**A MODEL FOR EVALUATING THE IMPACTS OF  
FRESHWATER OUTFLOW AND EXPORT  
ON STRIPED BASS  
IN THE SACRAMENTO-SAN JOAQUIN ESTUARY**

Entered by the California Department of Fish and Game  
for the State Water Resources Control Board 1992  
Water Rights Phase of the Bay-Delta Estuary Proceedings

## STRIPED BASS IMPACT MODEL - Preliminary Comments: D.G. Hankin

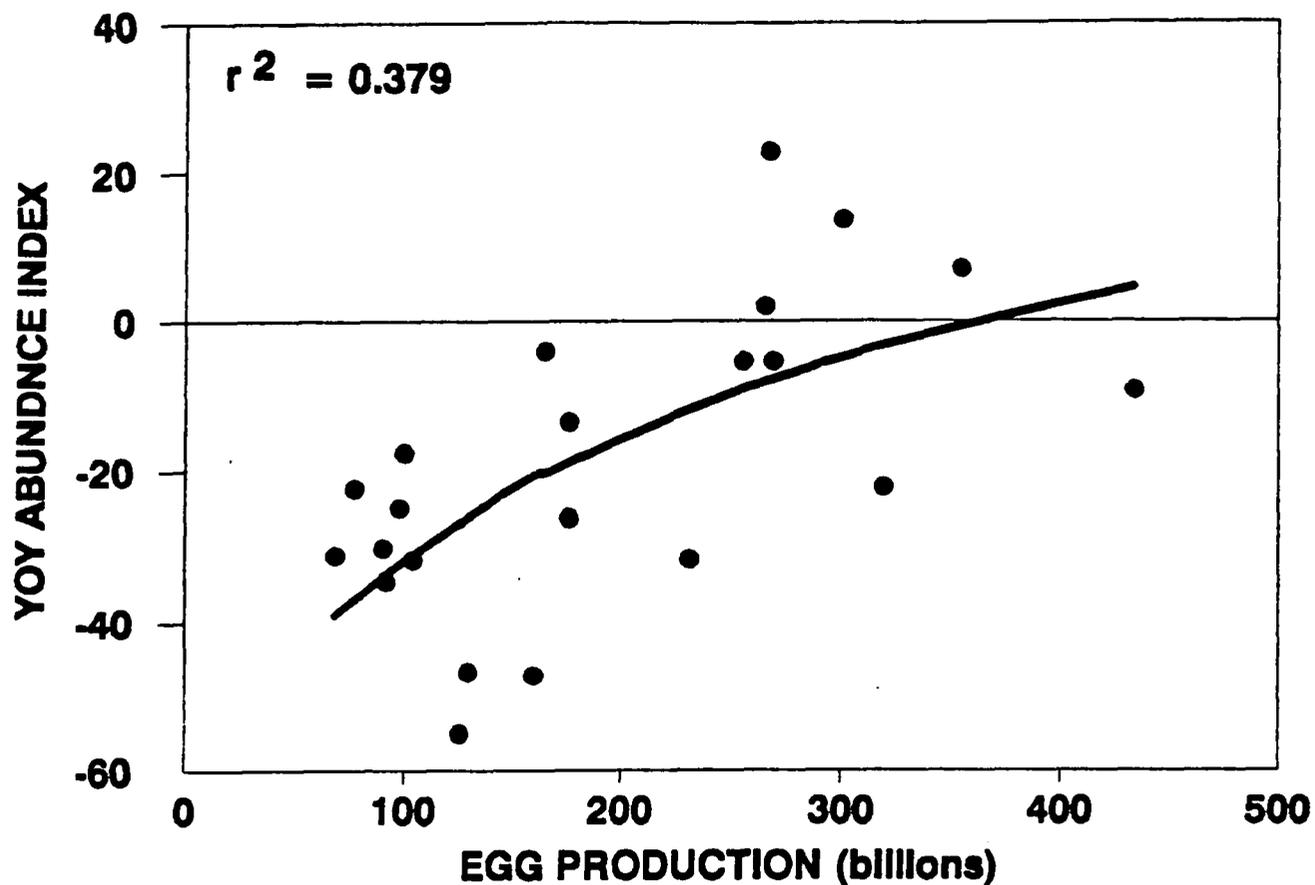
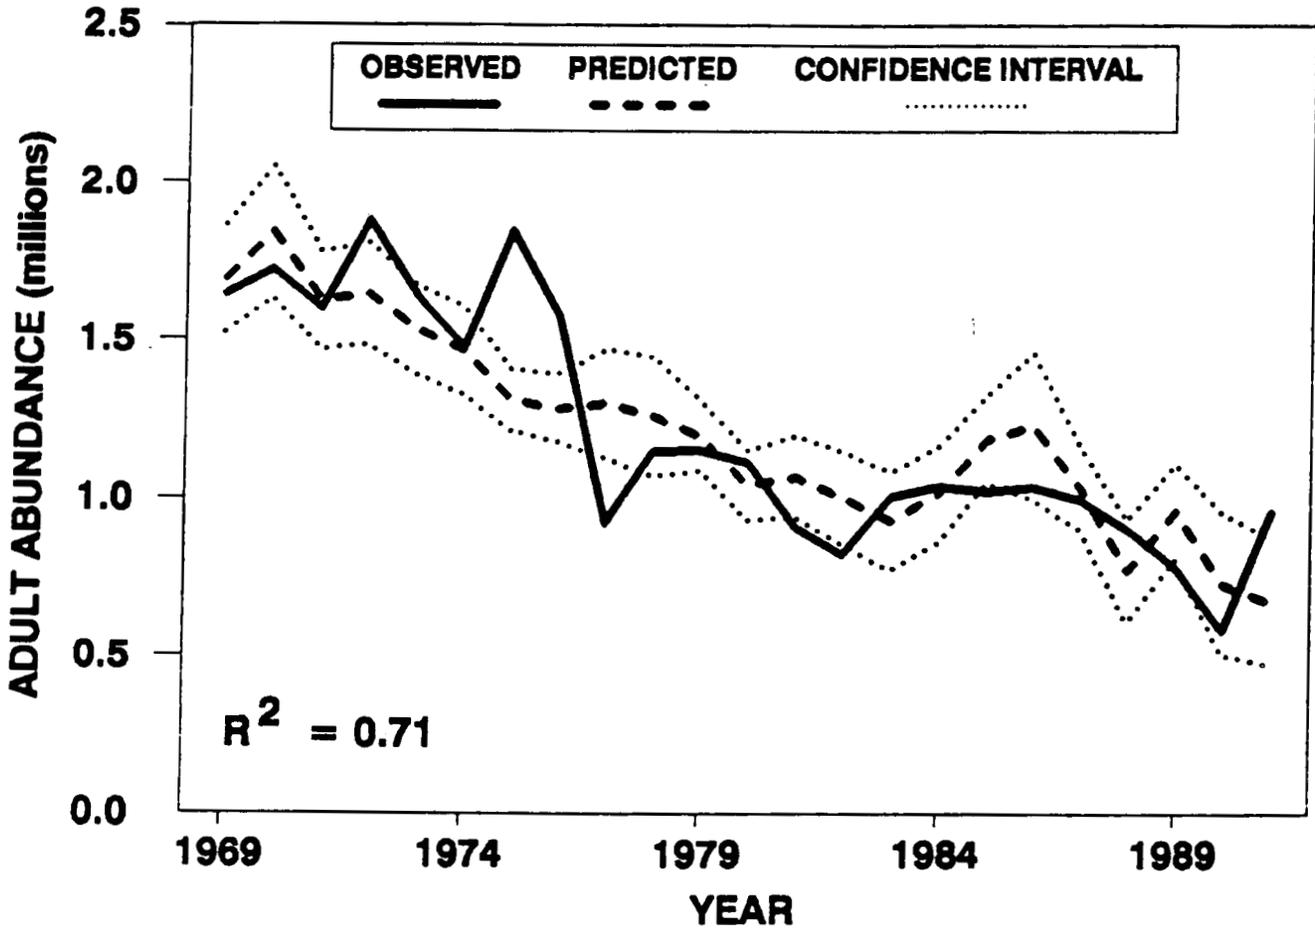
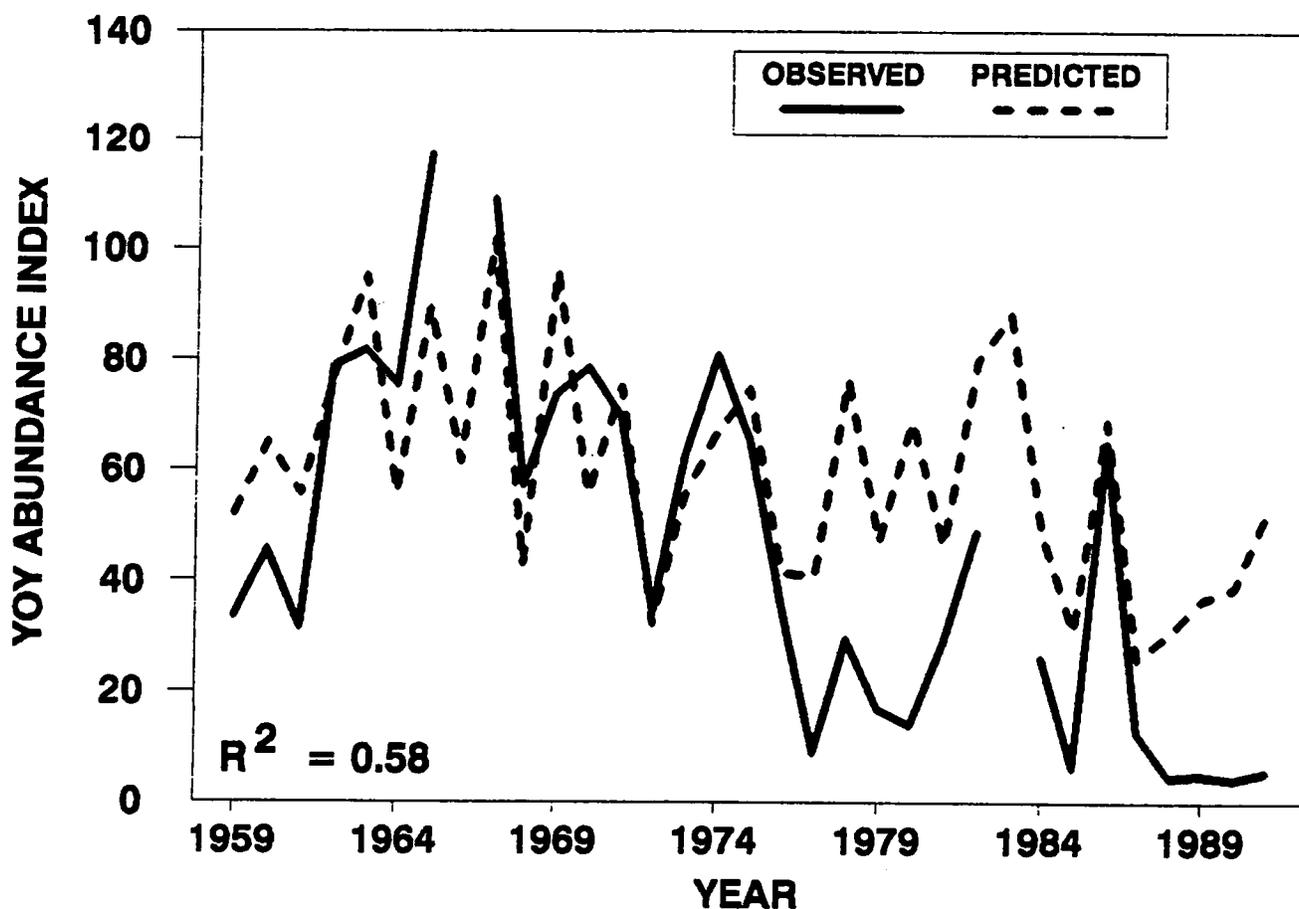
The poor fit at the upper end of Figure 8 may be the result of forcing a linear fit to what may be curvilinear relationships. Certainly the relationship in Figure 6 would be expected to pass through the origin and approach an ultimate asymptote, and Figure 7 also suggests a curvilinear relationship.

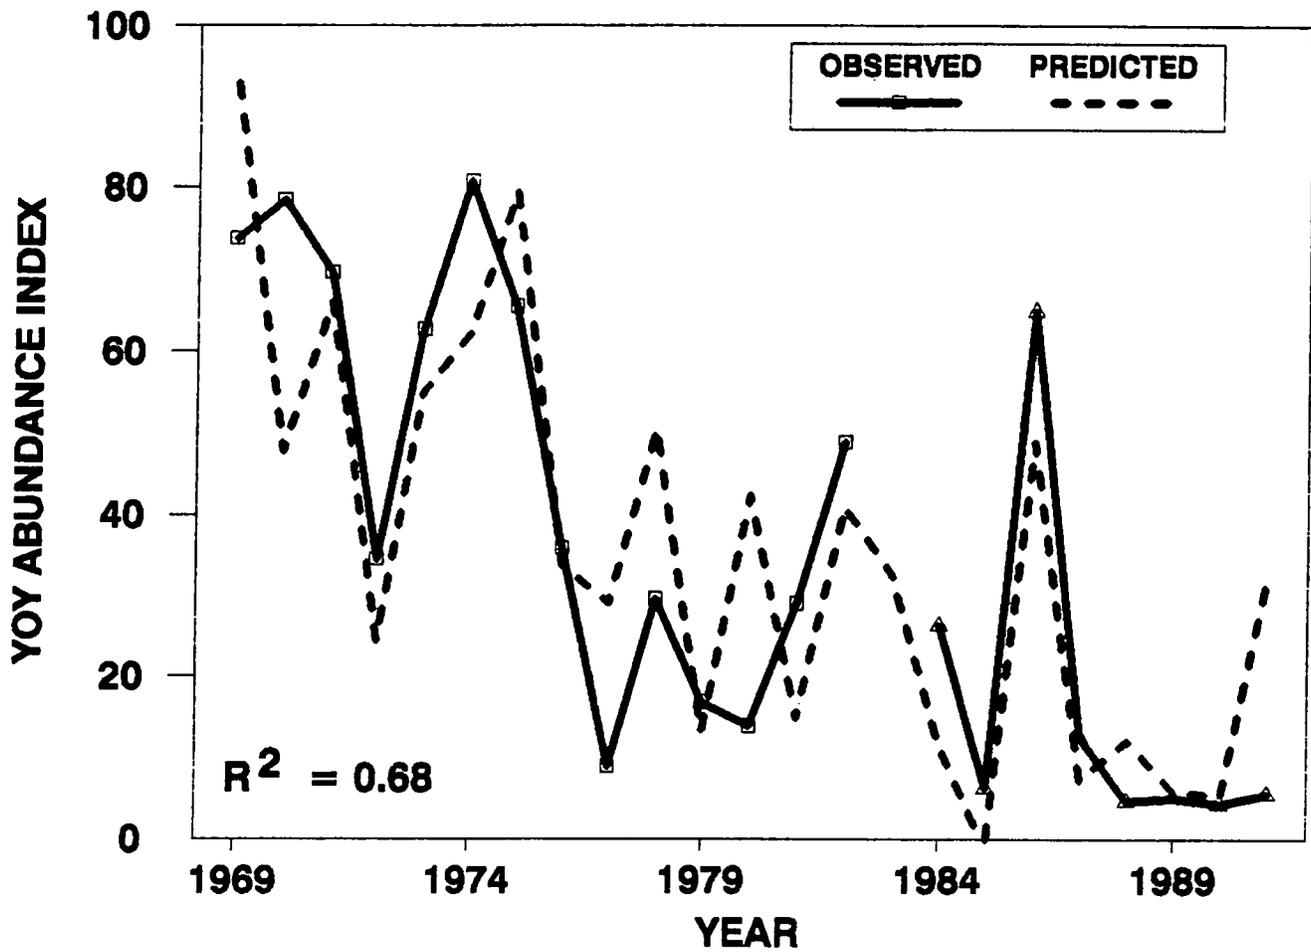
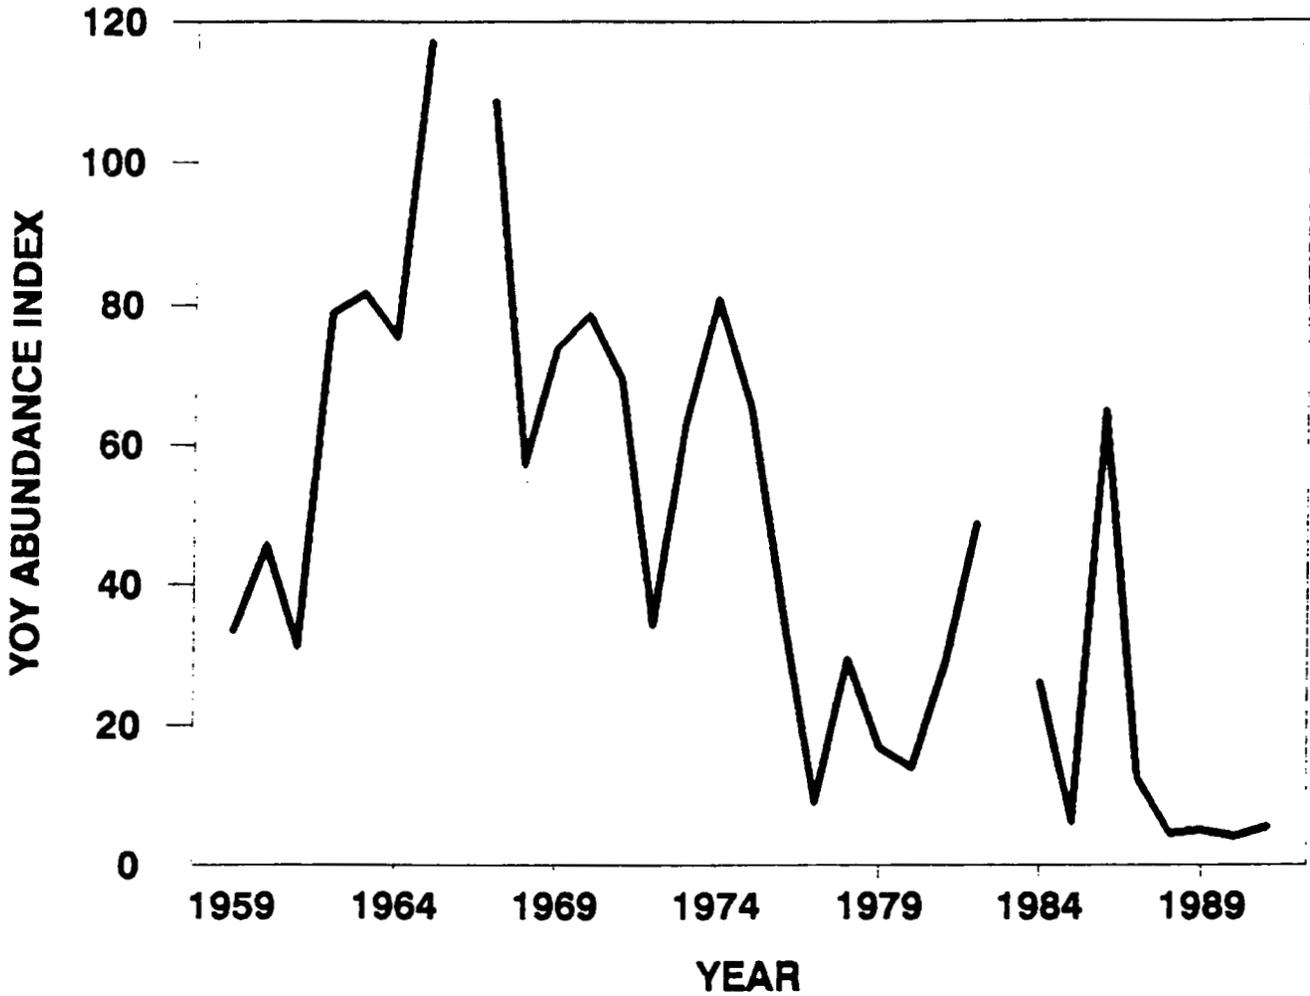
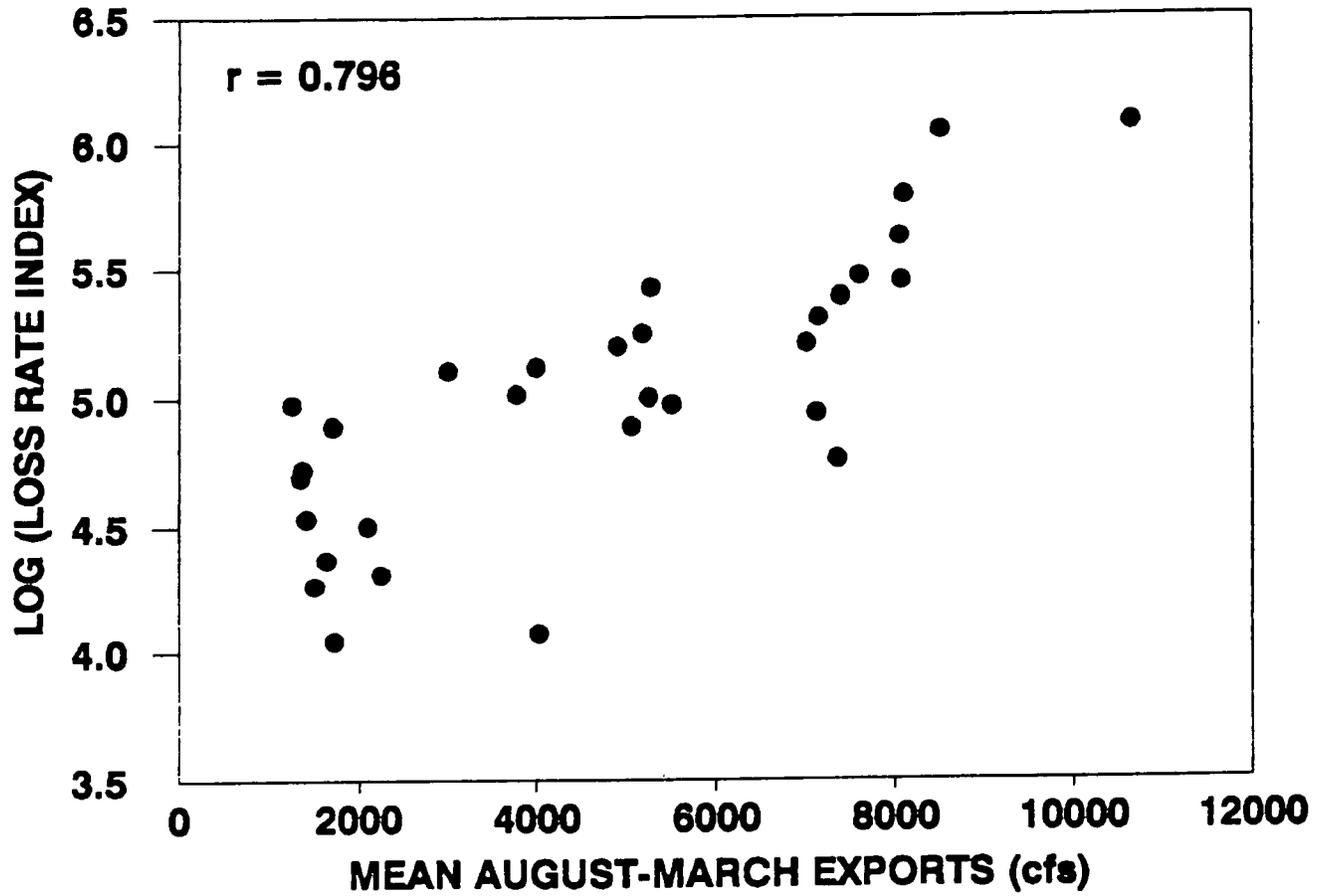
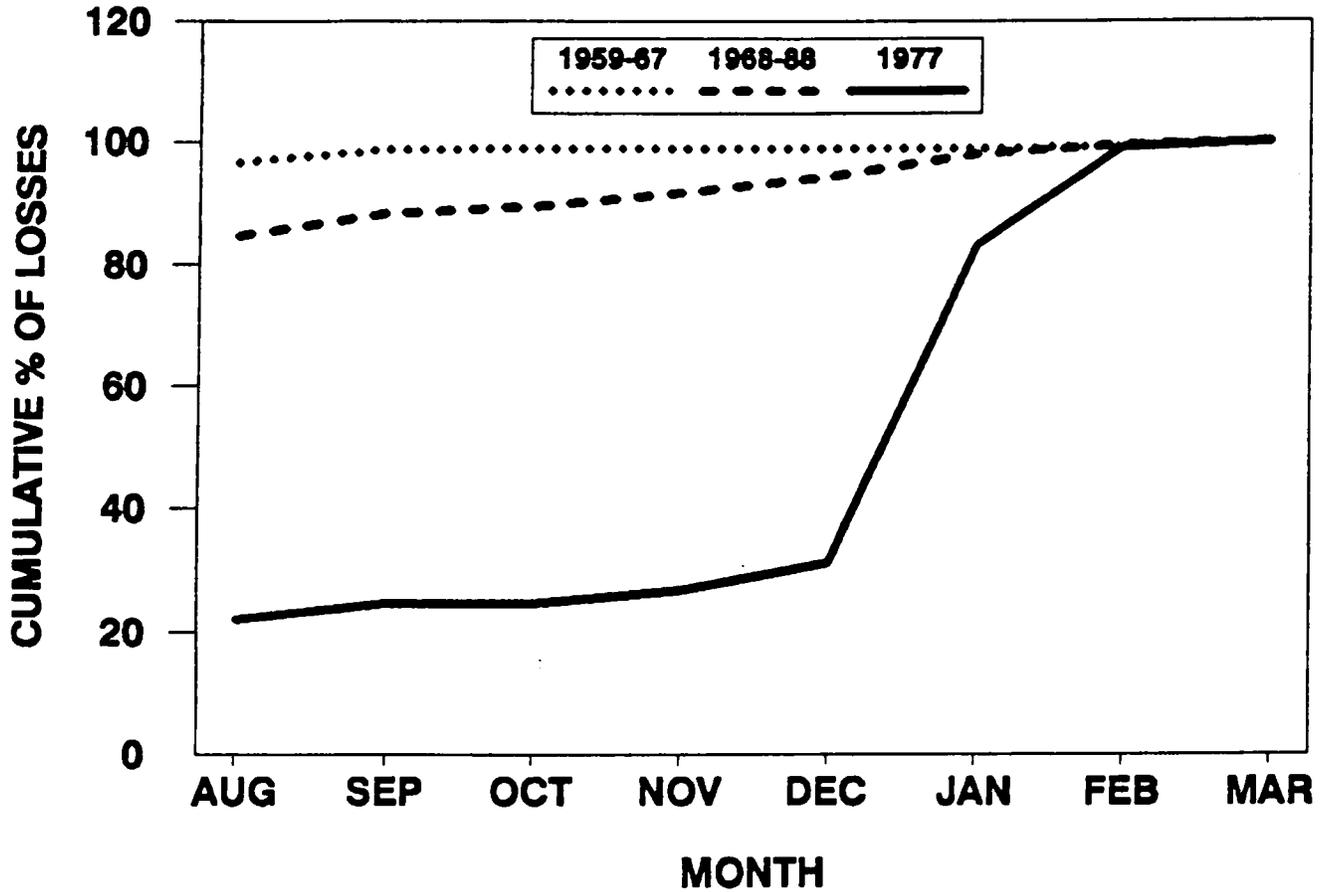
p. 4, par. 1           Why are there no observed values for 1966 and 1983 plotted in Figure 9, while they are given in Figure 2? The 1983 value seems to have been ignored, although not obviously omitted, in Figures 11 and 12 as well.
